April 27, 2005  
JAFP-05-0082

**SUBJECT: James A. FitzPatrick Nuclear Power Plant  
Docket No. 50-333  
Technical Specification Amendment to DC Electrical System Requirements**

**Description and Assessment**

Table 3.8.6-1 (page 1 of 1)  
Battery Cell Parameter Requirements

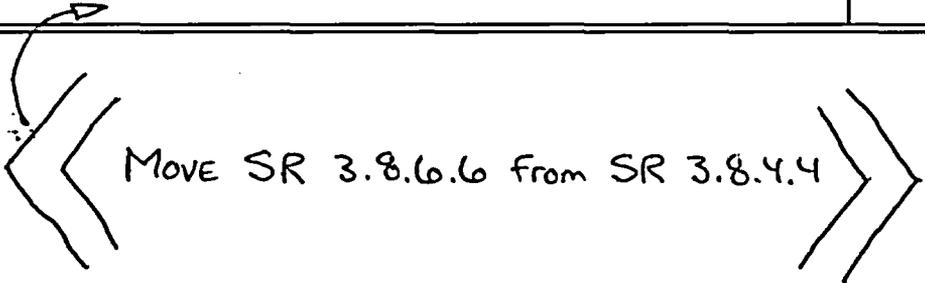
SURVEILLANCE		FREQUENCY
SR 3.8.6.2	Verify battery cell parameters meet Table 3.8.6-1 Category B limits.	92 days
SR 3.8.6.3	Verify average electrolyte temperature of representative cells is $\geq 65^{\circ}\text{F}$ for each 125 VDC battery, and $\geq 50^{\circ}\text{F}$ for each 419 VDC LPCI MOV independent power supply battery.	92 days

MOVE SR 3.8.6.6 From SR 3.8.4.4
